York Street Interchange

Public Inquiry
Technical Paper

City Reparo Alternative
Design Proposal

10 November 2015

Drawing Title: **YORK STREET INTERCHANGE PLAN & PROFILE CITY REPARO ALTERNATIVE M3 TO WESTLINK LINK**

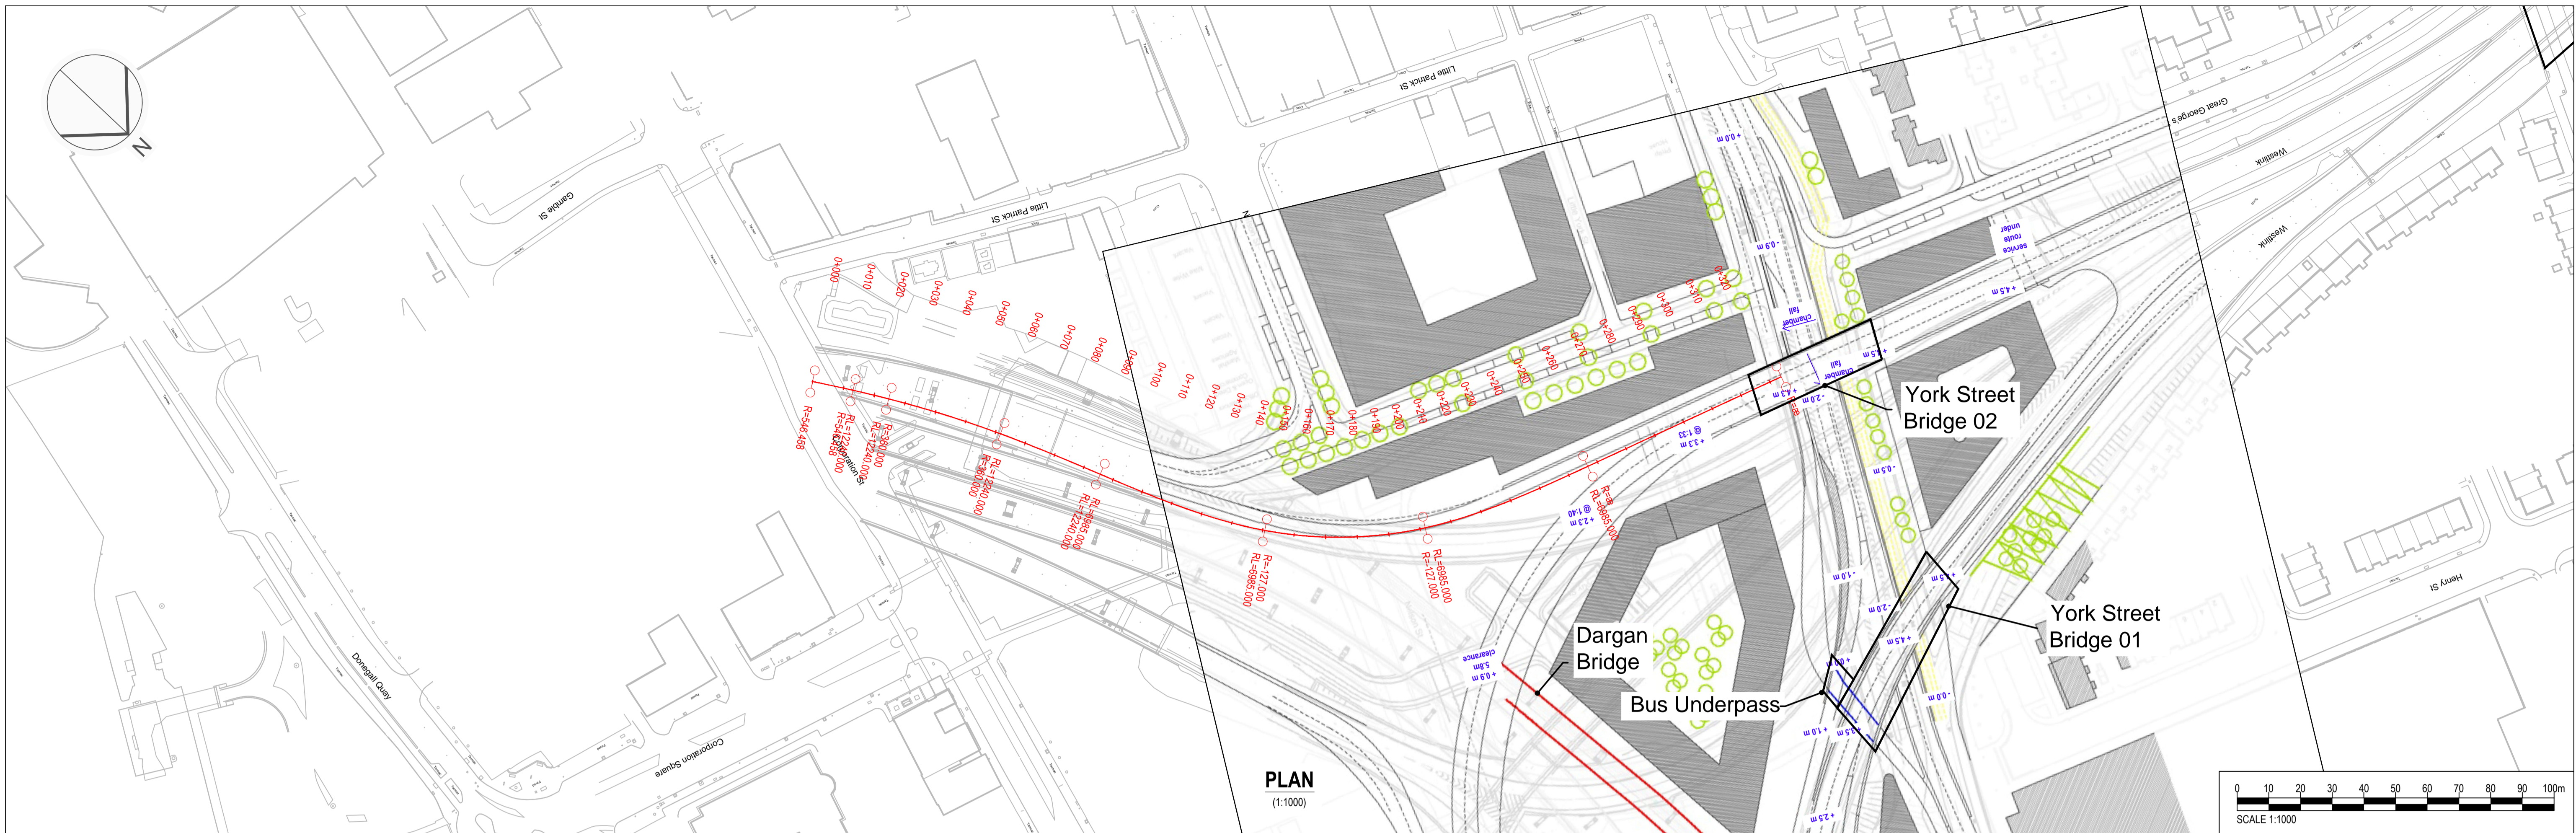
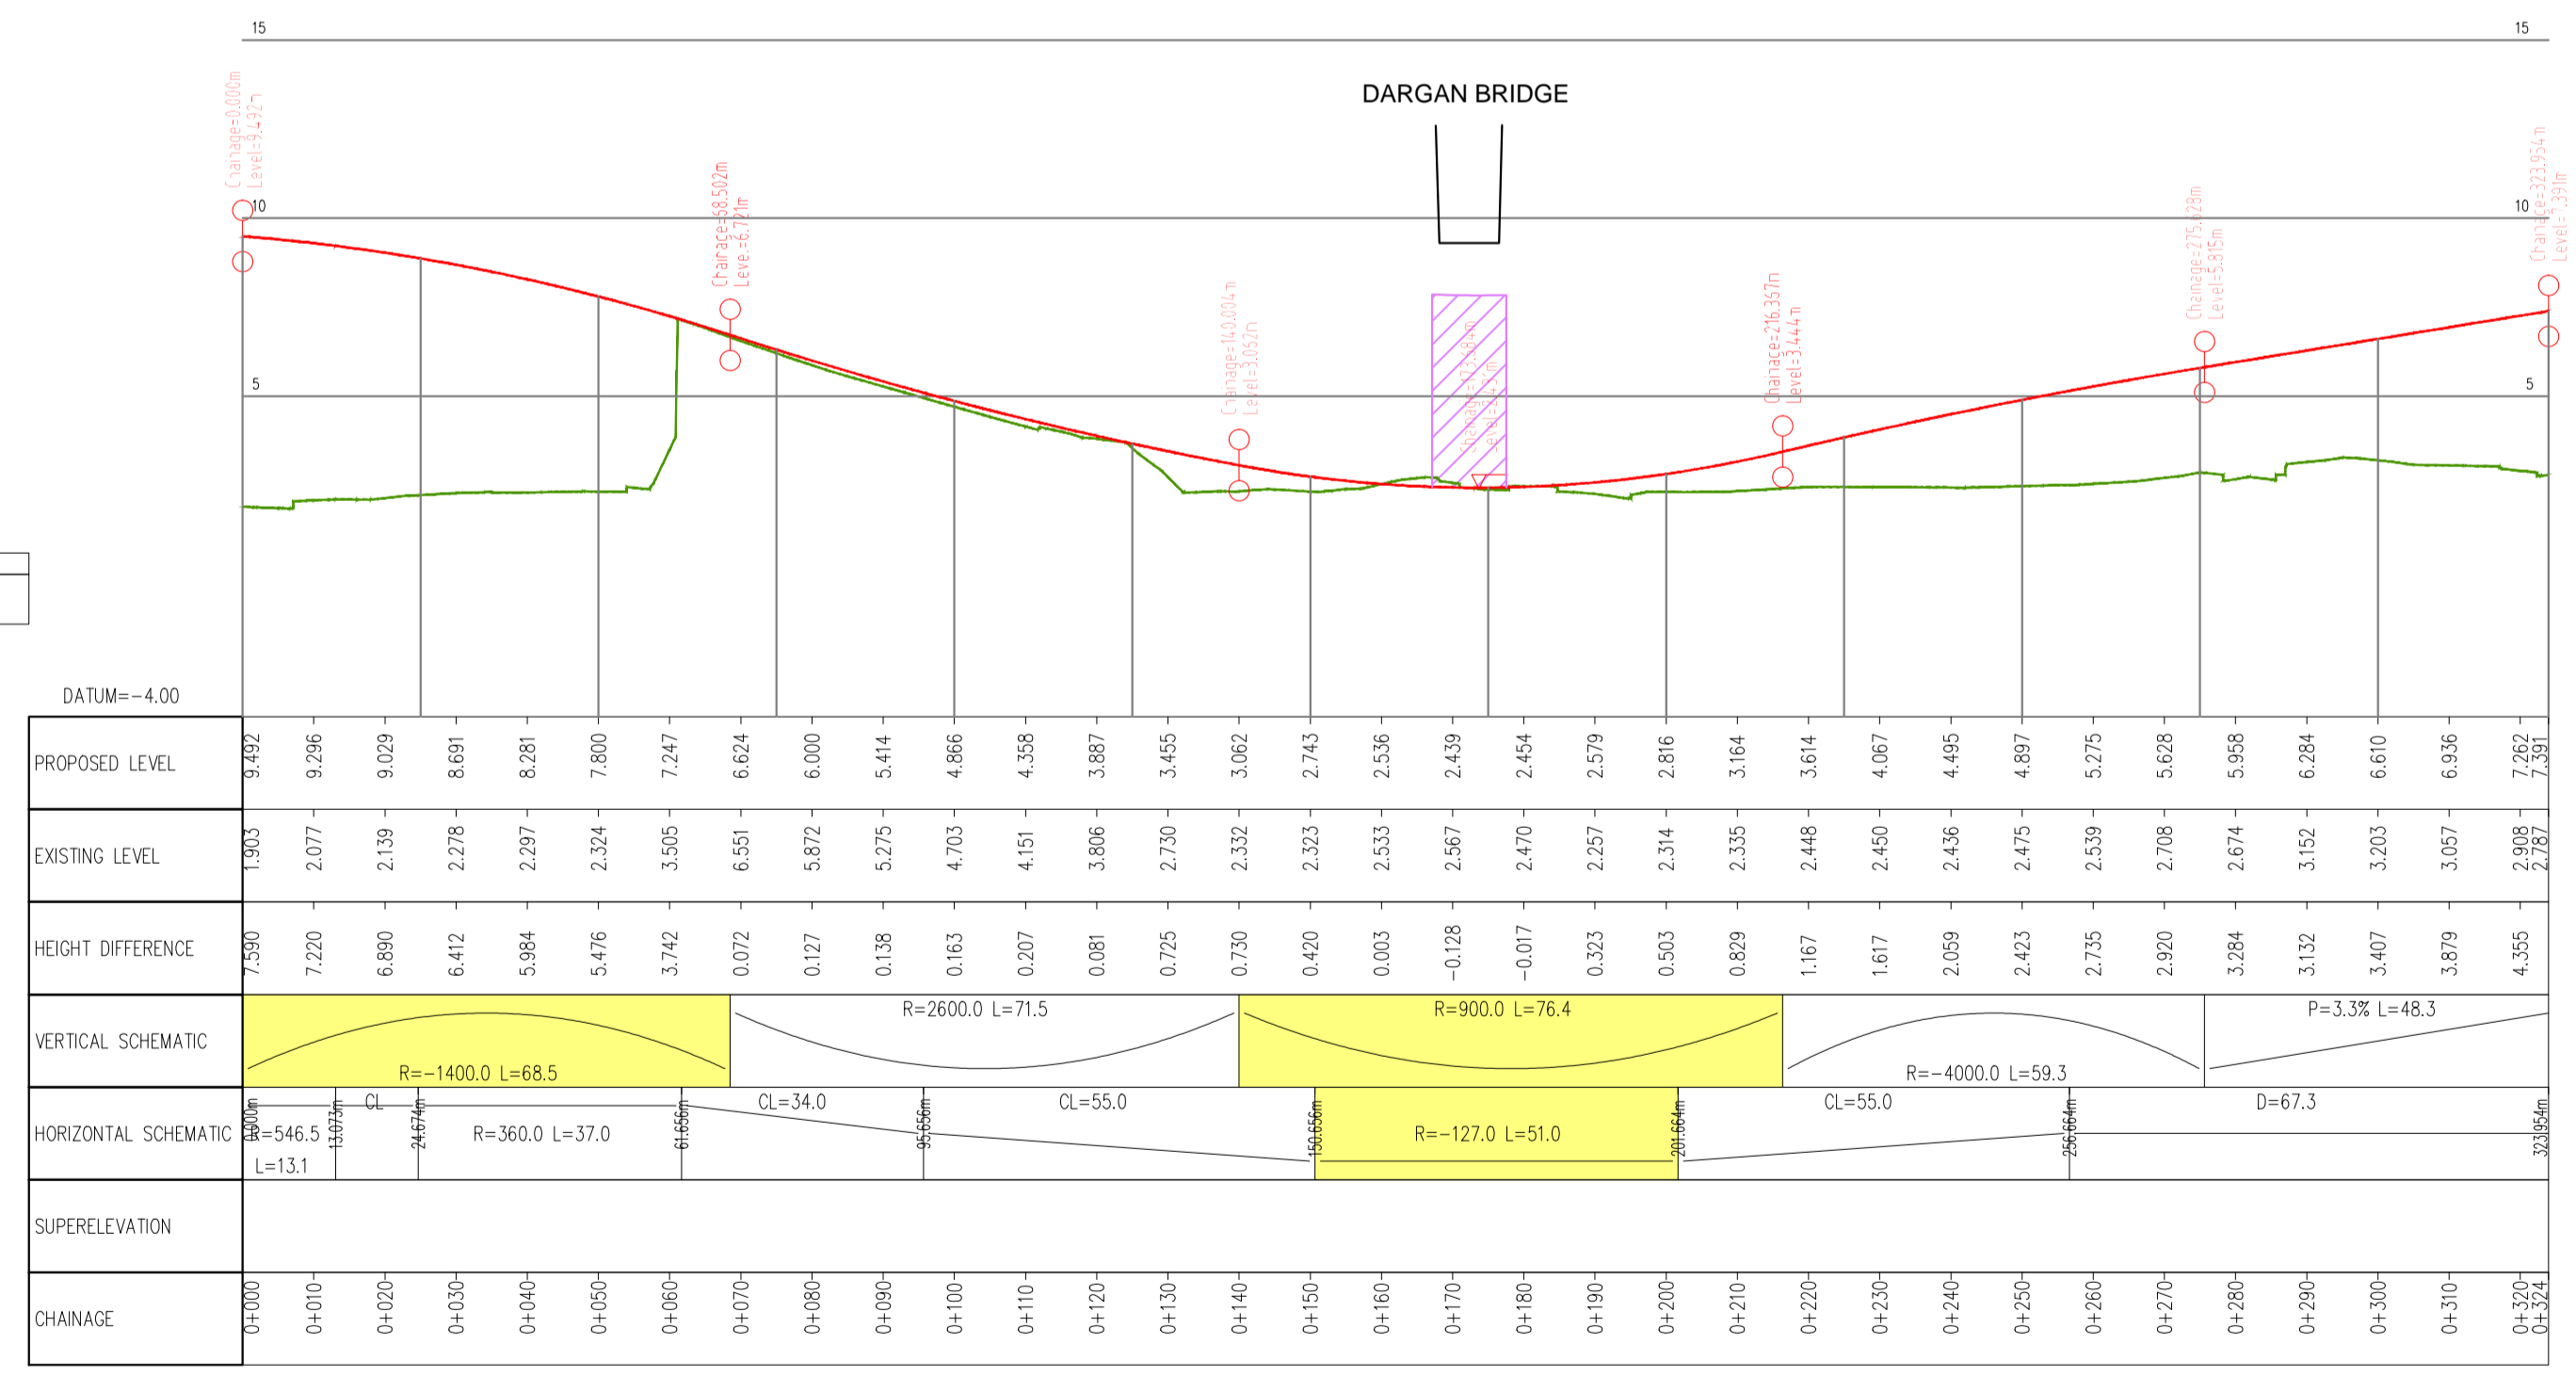
- A new interchange link is provided between the M3 and Westlink via an alignment to the north of the existing off-slip arrangement, similar to the alignment of the Proposed Scheme. However, the main radius on the alignment under Dargan Bridge appears to be significantly less than the Proposed Scheme, to facilitate a connection to the realigned M2 to Westlink link. A single lane is provided between the M3 and Westlink that joins the adjacent M2 to Westlink link and continues over the new York Street overbridge.

- No detail is provided of the proposed treatment of the southbound lanes heading towards Westlink. At present, the three lanes leading away from York Street onto Westlink reduce to two lanes by North Queen Street bridge (with the outer lane 3 dropped). If this layout is to be retained in the CRP, two options exist, either:

- provide a lane reduction taper on the outer lane 3 on approach to North Queen Street bridge
 - provide an auxiliary lane merge for the M3 to Westlink movement.

- The use of a similar lane drop on the outer lane 3 would cause associated disruption to traffic flows on both lanes of the M2 to Westlink interchange link. This would create congestion and reduction in air quality.

- Similarly, the use of an auxiliary lane merge for the M3 to Westlink movement would also cause associated disruption to traffic flows on the M3 to Westlink interchange link and lane 1 of the M2 to Westlink interchange link. This would create congestion and reduction in air quality.

- In the absence of clarity, it is assumed that City Reparo intends to mirror the provision within the Proposed Scheme, with the widening of North Queen Street bridge on its southern side to provide a three lane weaving section over North Queen Street bridge and a lane drop to Clifton Street. This approach would be consistent with their stated aims for their CRP, i.e. to “...reduce congestion and pollution in the middle of the city to meet EU regulations.”
